***Longfellow Energy Impound 24 Recycling  
Containment***

**Subject:** Longfellow Energy – Impound 24 C-147 - Additional Information Request

Furthermore, Longfellow Energy would like to use this letter to clarify the proposed secondary liner as 40 mil HDPE and not 60 mil HDPE as stated on the application submitted November 2, 2020. Updated sheets CS-101 (General Note 9) and CS-501 (Details 2, 3, 4 and 5) are attached to this submittal.

CS-501

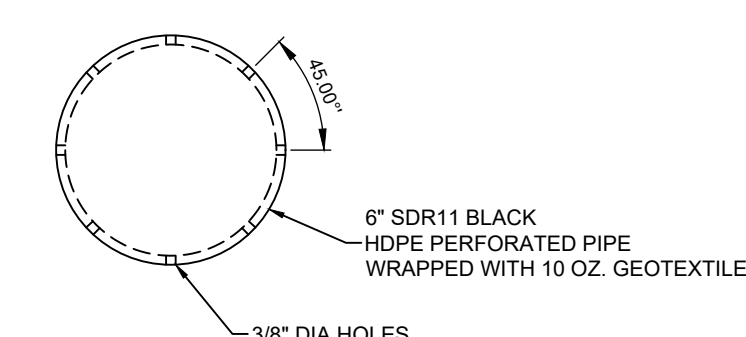
It is in my professional opinion that the chain link fence, six feet in height with a minimum of three strands of barbed wire over the top of the chain link will provide equal or better security to the facility against unauthorized wildlife and human access. Chain link fence details can be found on sheet CS-501, detail 6.

On behalf of Longfellow Energy, Pettigrew and Associates is requesting a variance to Section 19.15.34.12(A)(4) requiring secondary liner to be 30-mil LLDPE string reinforced. Longfellow Energy is requesting approval to use 40-mil HDPE liner.
